PLAN REVISION SUMMARY

CONSTRUCTION
DRAWING

CHARLESTON HOMES		
HOME FOR: COLIN EDWARDS		
DRAWN BY: ALVIN W. BROWN	SCALE: 3/16" = 1'0"	
MODEL: "CUSTOM"	DATE: APR. 04	
APPROVED GRADING: AUG,19,04.	SELEC TIONS: AUG,11,04.	
PRE-CONSTRUC T: SEPT,16,04.	CONSTRUCT: SEPT,27,04.	
LOCATION: LOT # 207 TANNERS DR. DEVON PLACE	JOB. NO. 207XX

FRONT ELEVATION

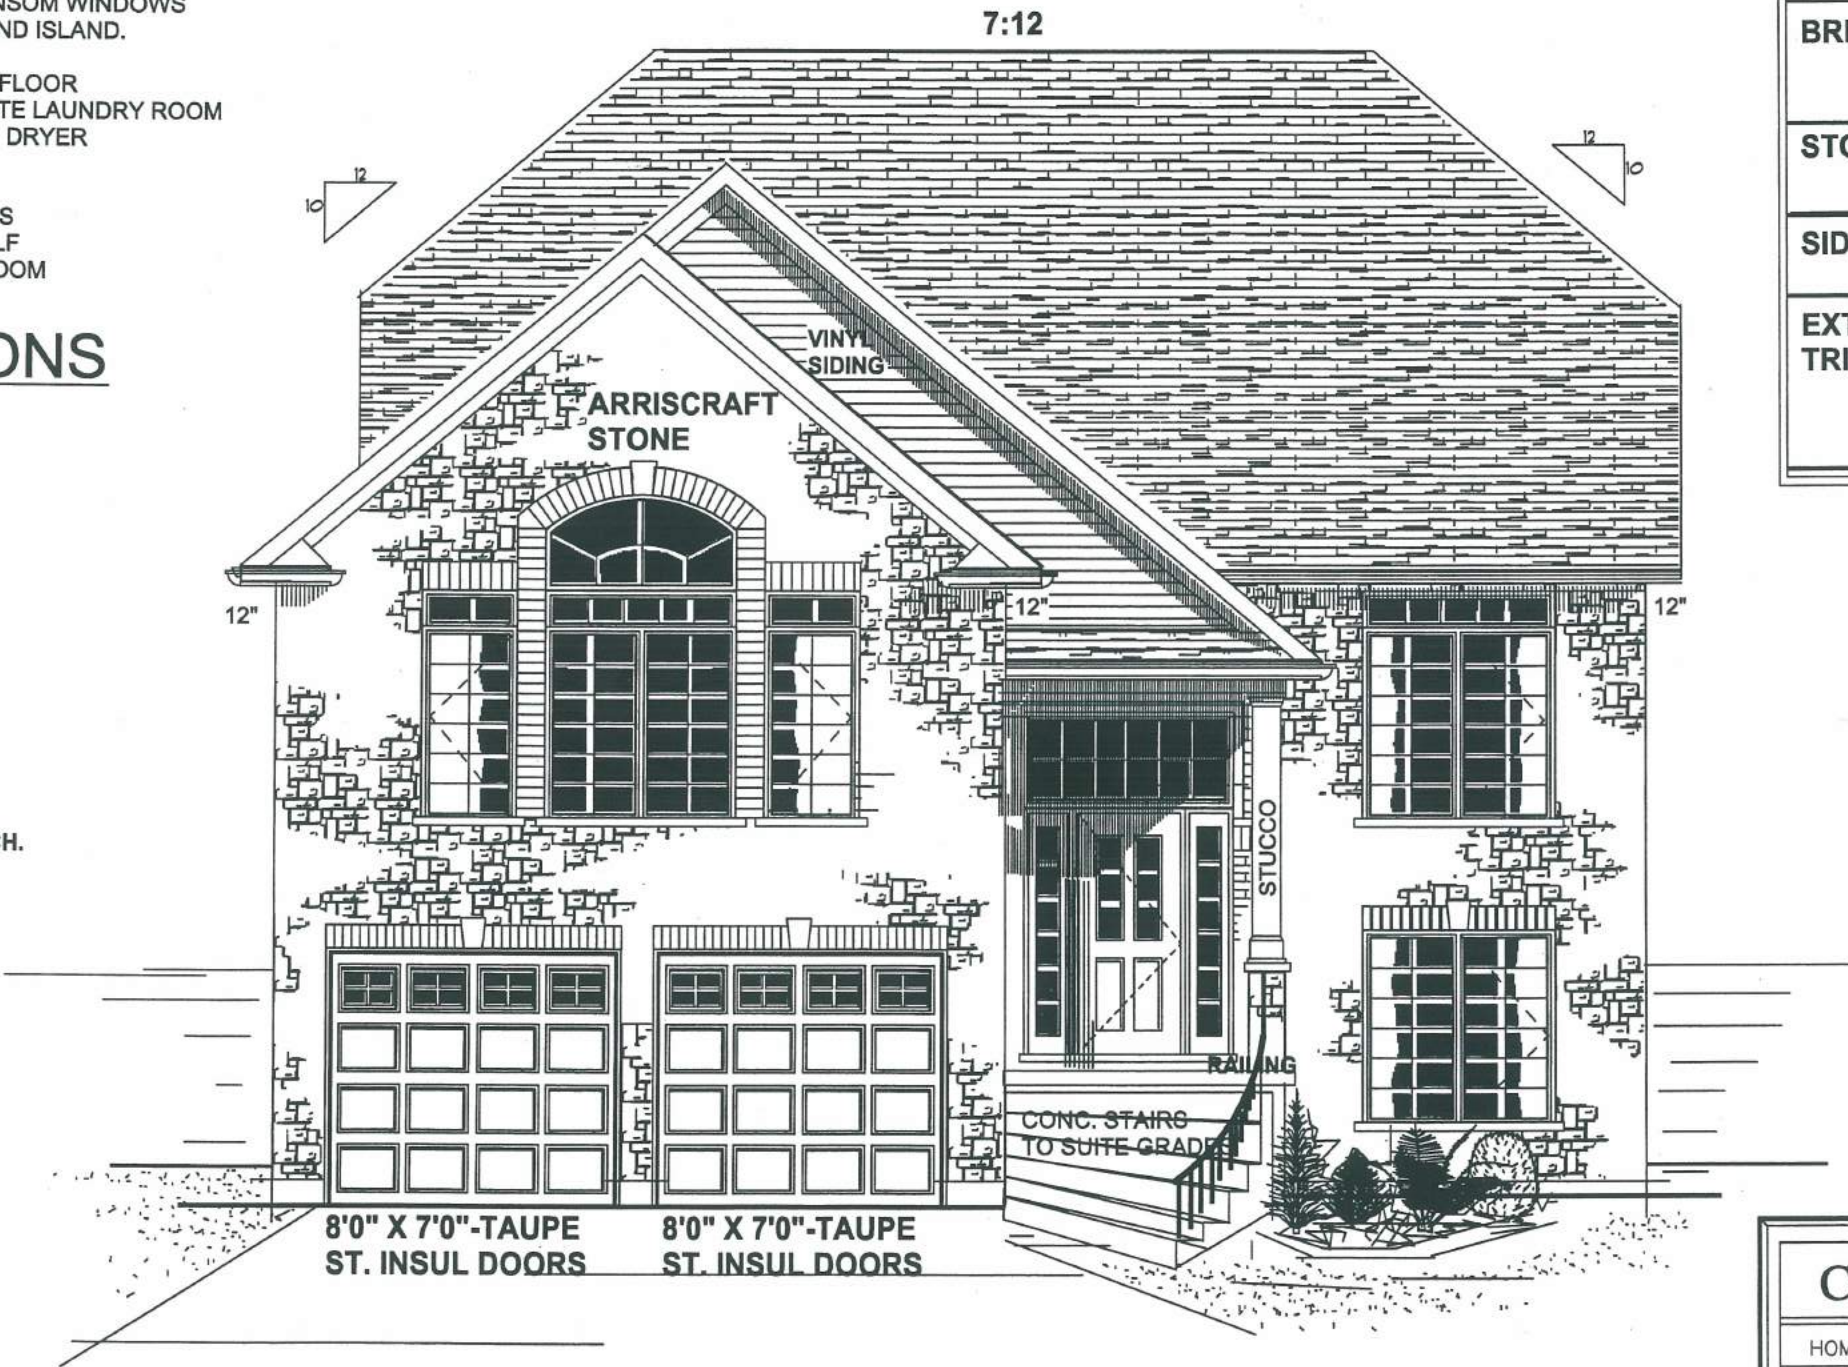
- ADD OPTIONAL CATHEDRAL CEILING IN MASTER BEDROOM
- ADD DOUBLE DROP TRAY CEILING IN DINING ROOM
- ADD LOW WALLS ,COLUMNS & ARCH DETAIL TO ENTRANCE OF GREAT ROOM AND DINING ROOM.
- UPGRADE FIREPLACE TO DETAIL #3
- INCLUDE FRAMELESS GLASS SHOWER IN ENSUITE c/w STEP UP TO SOAKER TUB.
- UPGRADE MAIN FLOOR TO 9 FT. CEILINGS c/w TRANSOM WINDOWS
- ALLOW FOR GRANITE COUNTER ON RAISED BAR AND ISLAND.
- ADD 3 PC BATH ROUGH-IN IN BASEMENT
- MOVE LAUNDRY ROOM FROM BASEMENT TO MAIN FLOOR
- REVISE MAIN FLOOR HALL CLOSET TO ACCOMODATE LAUNDRY ROOM
- ADD CLOSET TO HOUSE STACKABLE WASHER AND DRYER
- ADD WHIRLPOOL JETS TO ENSUITE 40 R 40
- ADD CATHEDRAL CEILING IN GREAT ROOM
- UPGRADE MAIN FLOOR HALLS TO CERAMIC FLOORS
- ADD DEEP FRIDGE UPPERS AND MICROWAVE SHELF
- ADD UPPER AND LOWER CABINETS IN LAUNDRY ROOM

- REVISE TO CURVED STAIRS AT PORCH
- ADD TY-VEK HOUSE WRAP
- UPGRADE TO 200 AMP. SERVICE
- UPGRADE TO CASEMENT WINDOWS
- UPGRADE FRONT TO STONE AS PER PLAN
- BASEMENT WINDOW CHANGES
- INSULATE DRYWALL AND TAPE GARAGE
- REVISED BASEMENT LAYOUT
- ROUND COLUMNS AT DINING , & GREAT ROOM
- REMOVE SHELF AND DOOR IN STUDY
- CHANGE TO BI-FOLD IN BEDROOM
- FRAMED PANTRY REMOVED AND CABINETS ADDED
- UNDER CABINET LIGHTS ADDED
- ADD M/W FAN COMBO:OMIT M/W SHELF
- ADD DESK IN KITCHEN
- ADD SECOND PINNED DOOR TO BREAKFAST ROOM
- GREAT ROOM TRANSOM REVISED TO ELIPTICAL ARCH.

LOWER LEVEL MECHANICALS

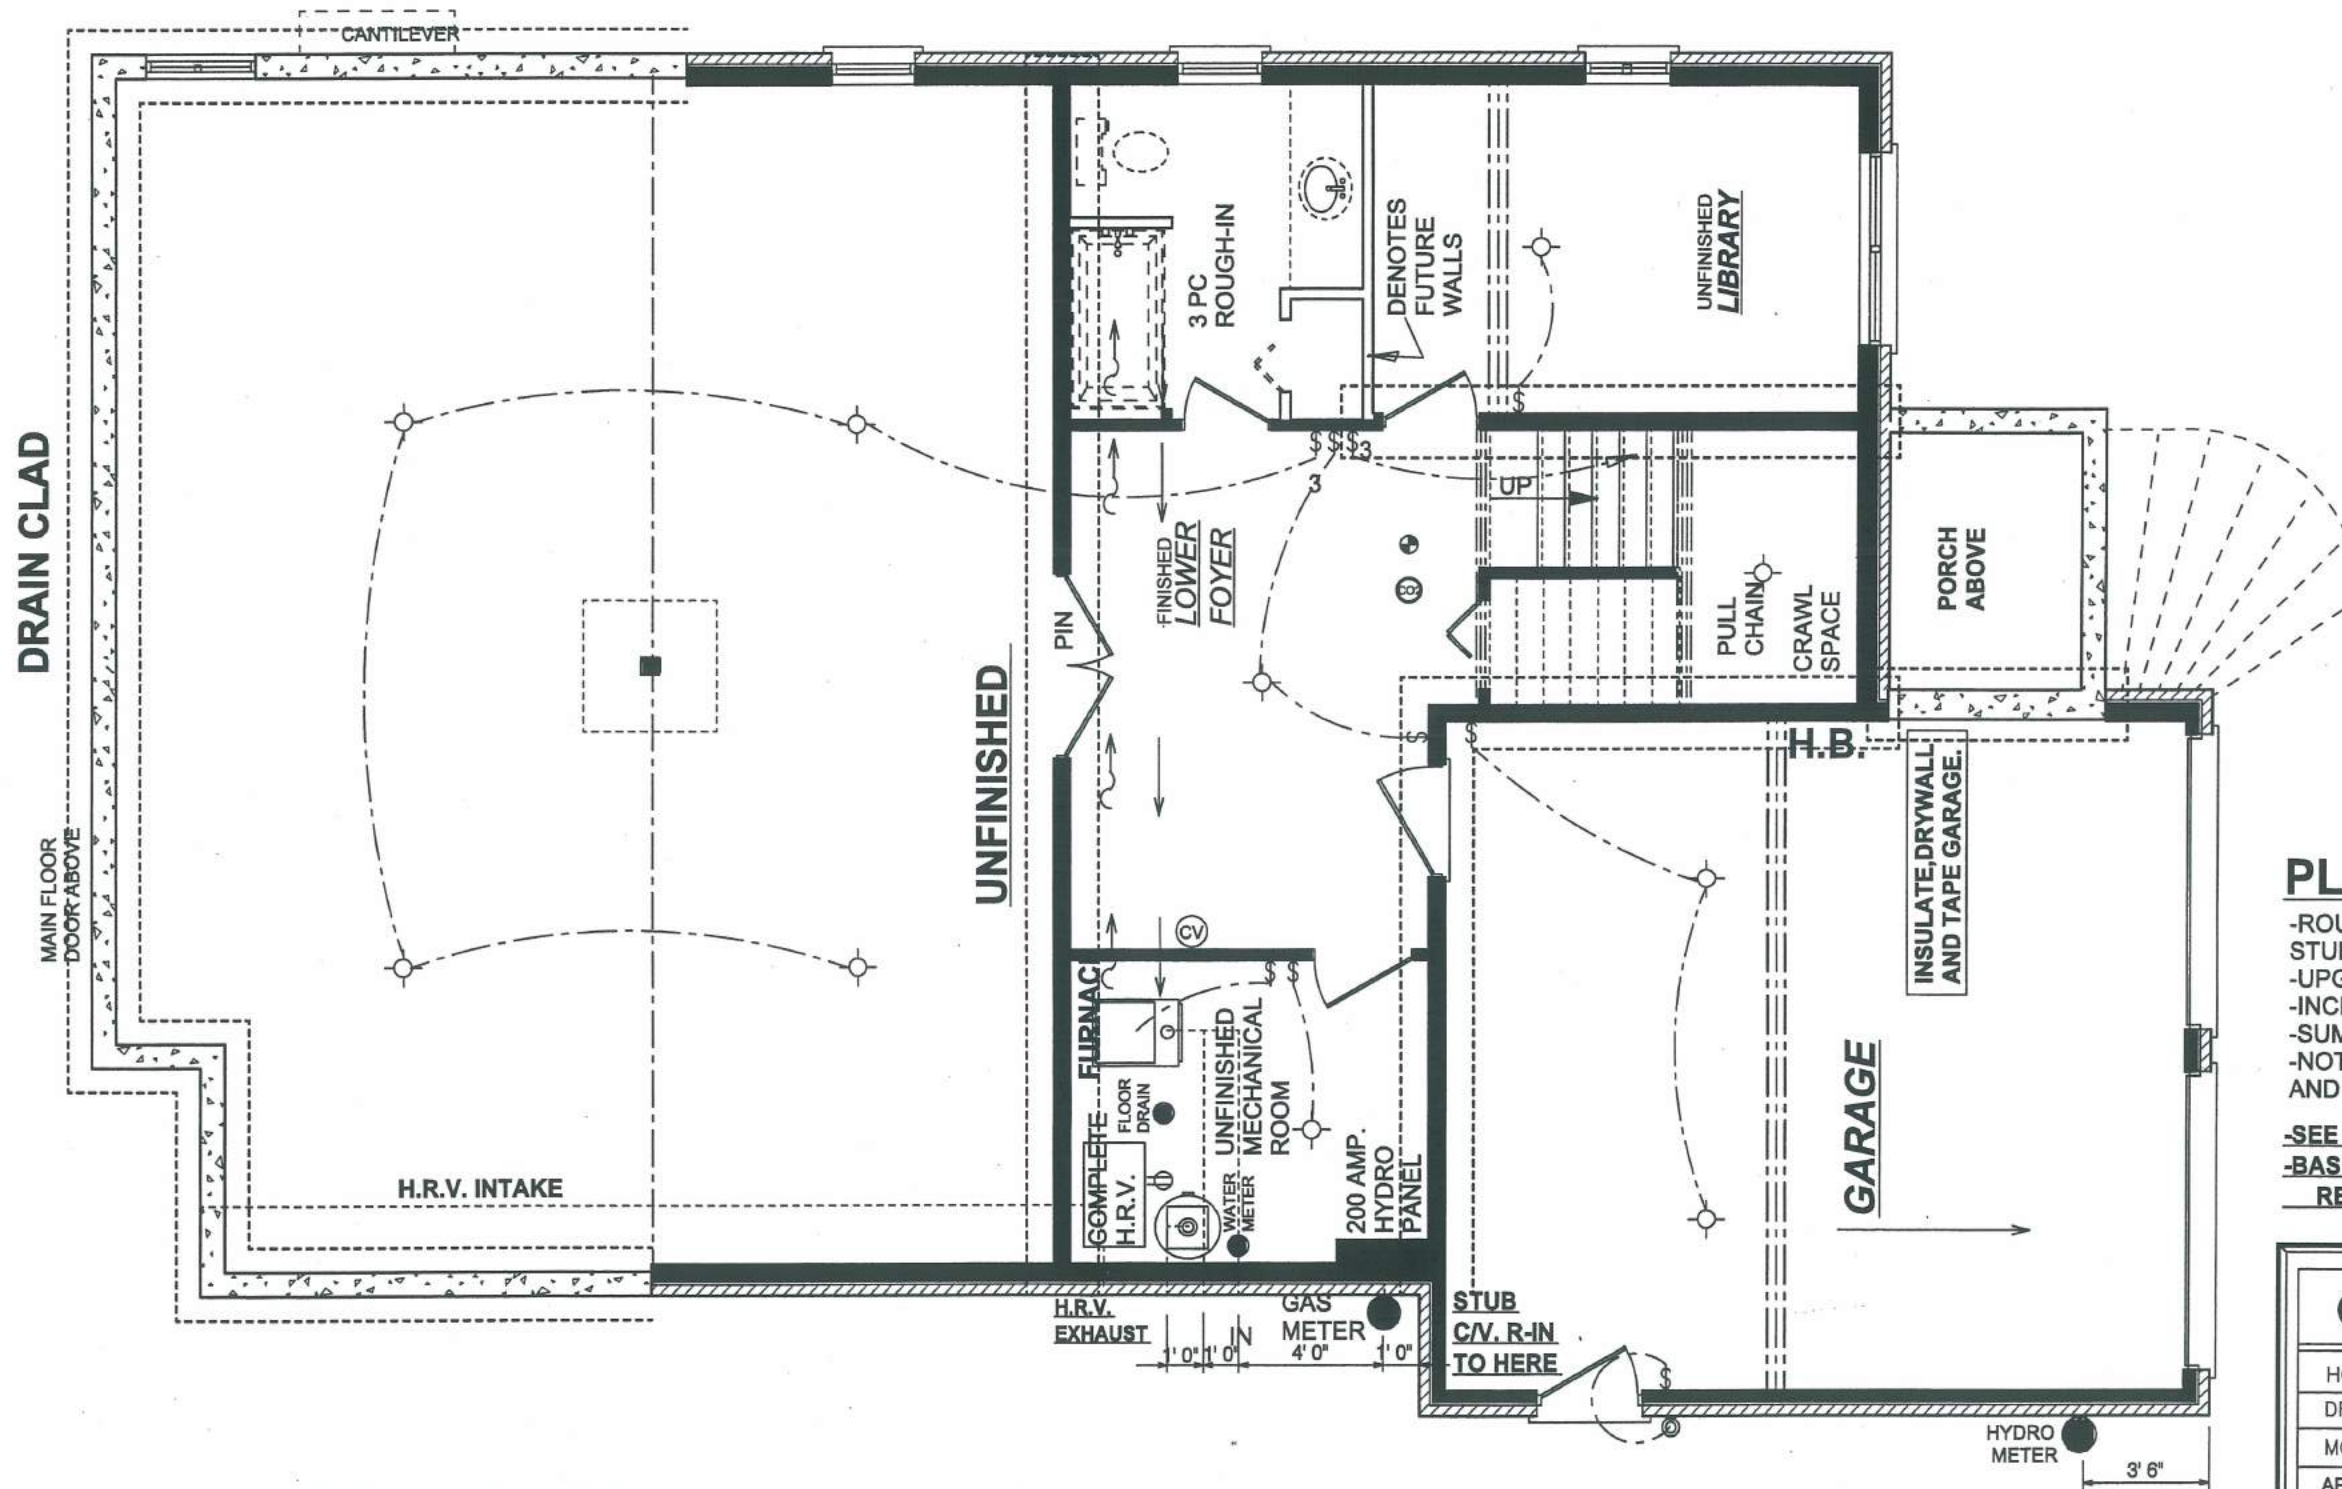
- ROUGH-IN C.V. IN LOWER FOYER & STUB IN GARAGE AS MARKED
- UPGRADE TO 200 AMP. HYDRO SERVICE
- INCLUDE COMPLETE H.R.V. SYSTEM
- SUMP PIT AS MARKED.
- NOTE. GARAGE IS INSULATED DRYWALLED AND TAPED

- SEE CHANGE ORDER FOR ADDED GARAGE MAN DOOR
- BASEMENT FOYER REVISED & MECHANICAL ROOM REVISED AT PRE-CONSTRUCTION.

MAIN FLOOR MECHANICAL PLAN
9 FT. CLG HGT 1938 SQ. FT.

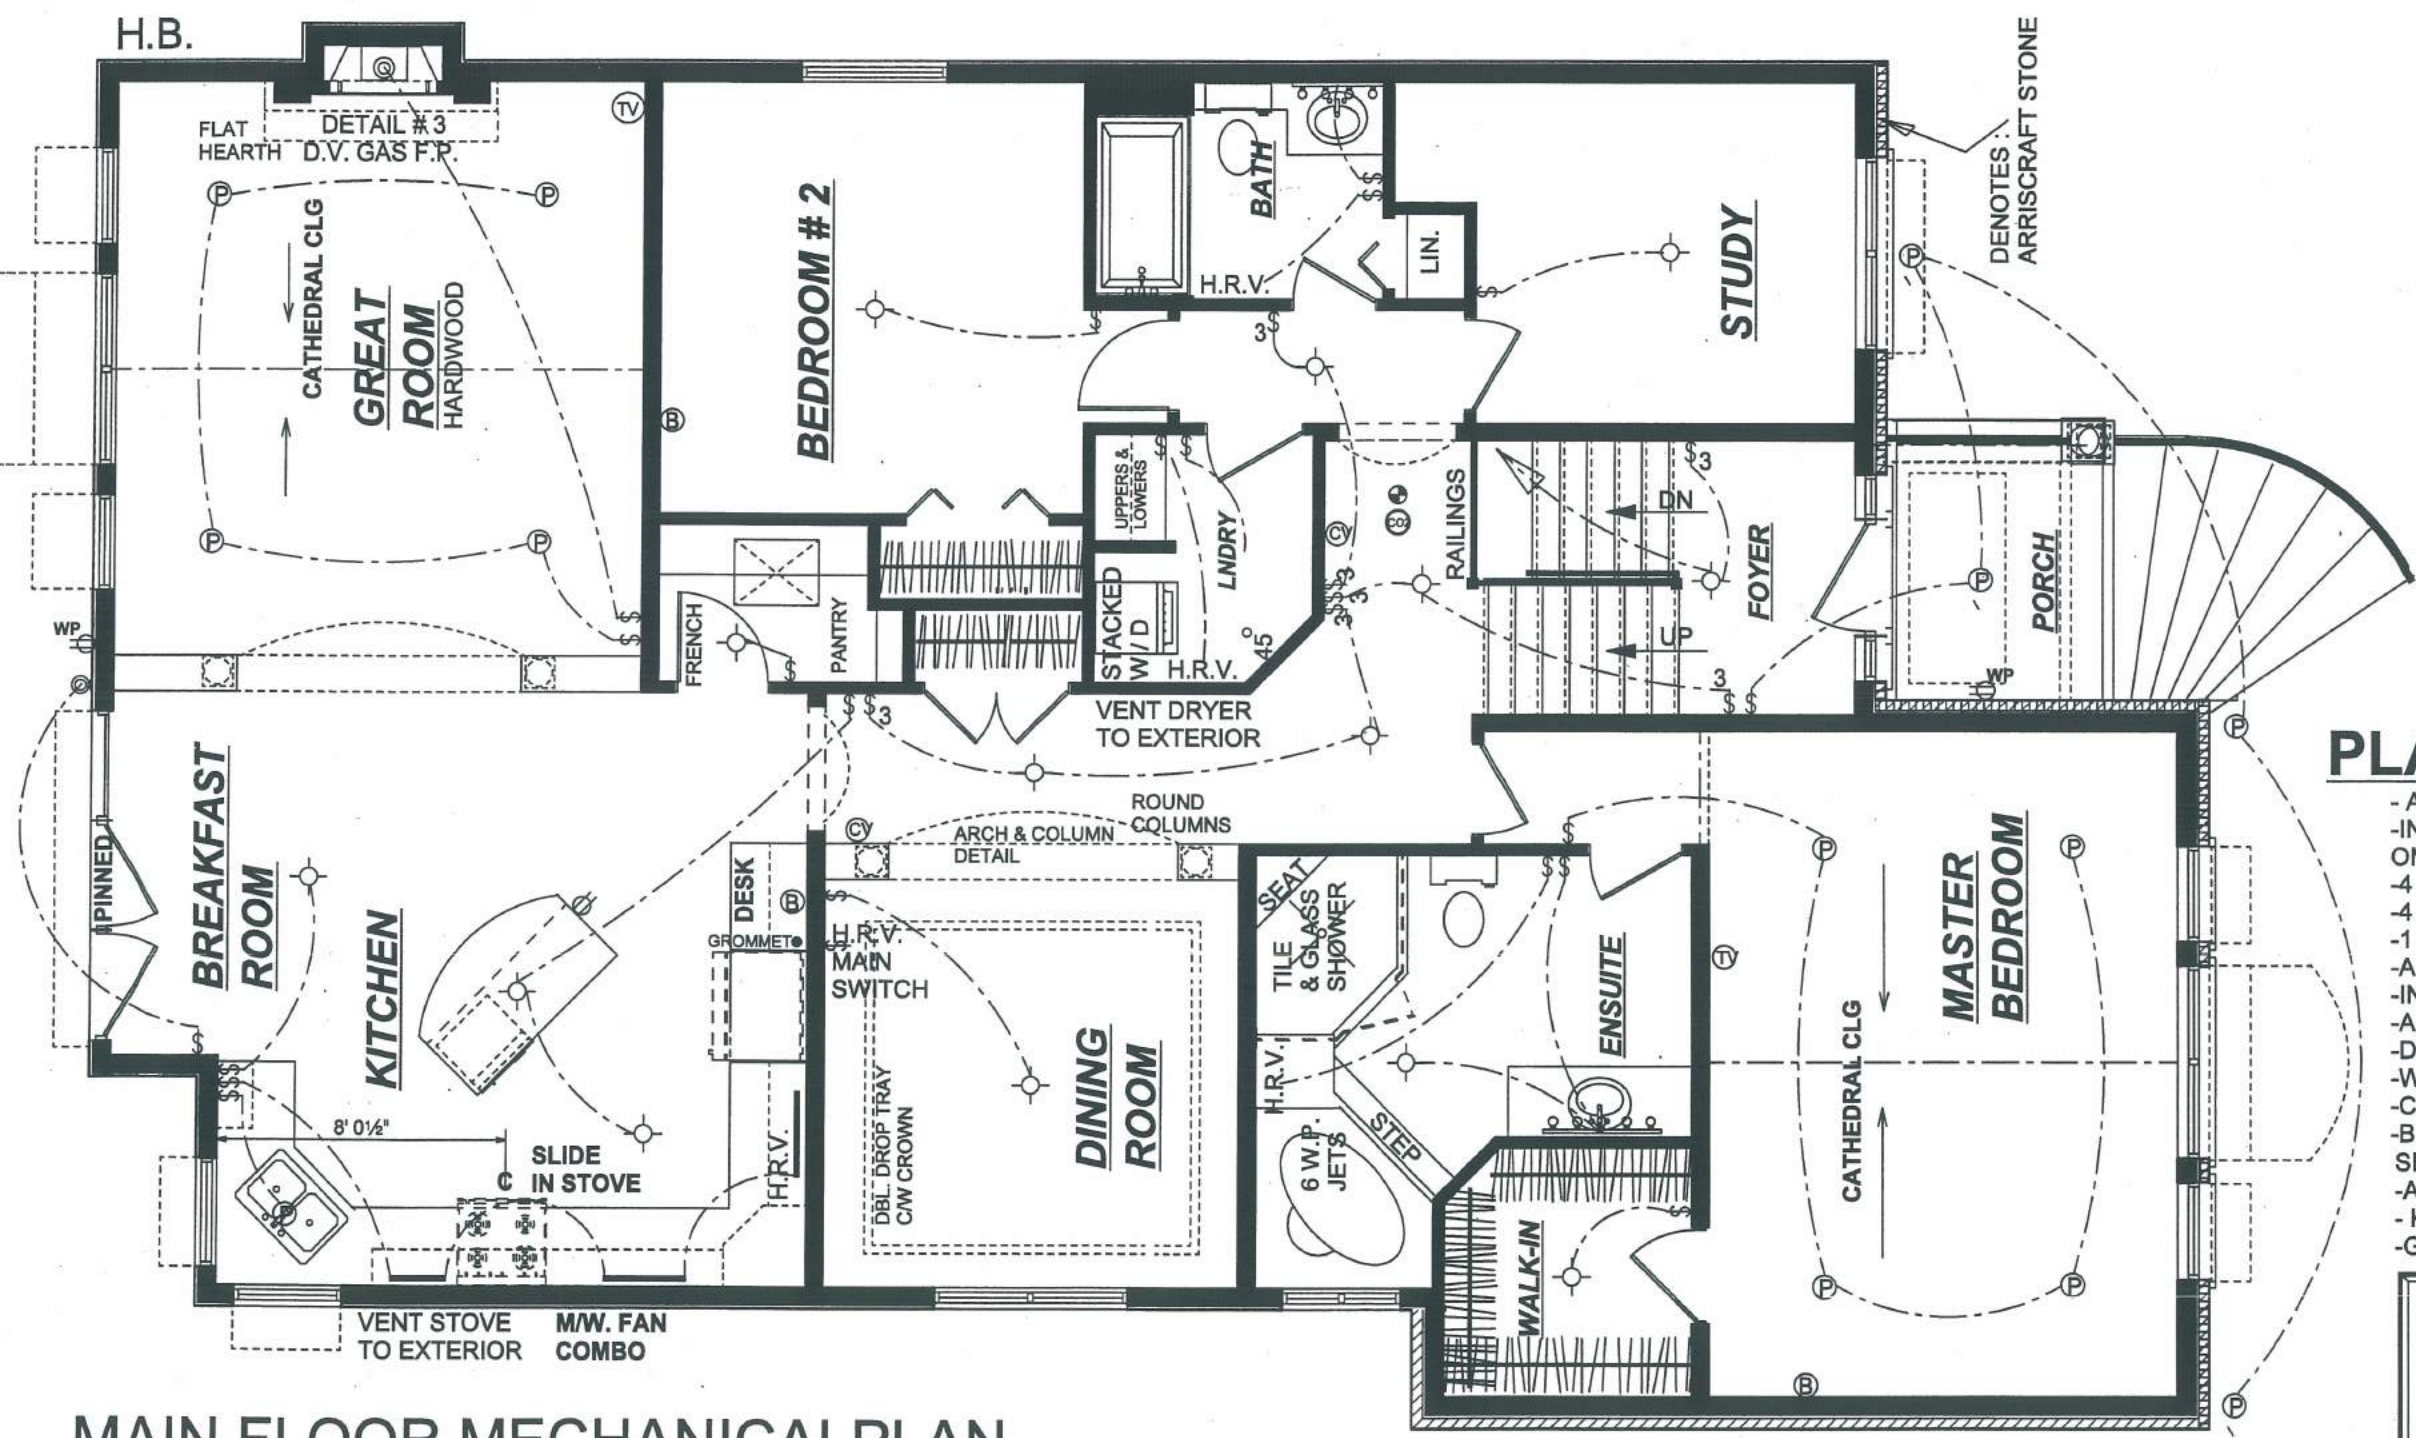
- ADD TWO C/V. DROPPS TO GARAGE
- INCLUDE H.R.V. TO BATHS AND KITCHEN: OMIT STANDARD EXHAUST FANS
- 4 : 4" POTS ADDED IN MASTER BEDROOM
- 4 : 4" POTS ADDED IN GREAT ROOM
- 1 : 4" POT ADDED OVER KITCHEN SINK
- ADD 3 UNDER CABINET LIGHTS ON ONE SWITCH
- INCLUDE M/W FAN COMBO
- ALLOW FOR SLIDE IN STOVE
- DETAIL # 3 FIREPLACE
- WASHER & DRYER ARE STACKED UNITS
- CABINETS INCLUDED IN LAUNDRY
- BELL AND CABLE T.V. AS MARKED
- SEE CHANGE ORDERS FOR:
- ADDED OUTLET ON ISLAND,
- KITCHEN FLOOR SWEEP.
- GROMMET ADDED TO DESK
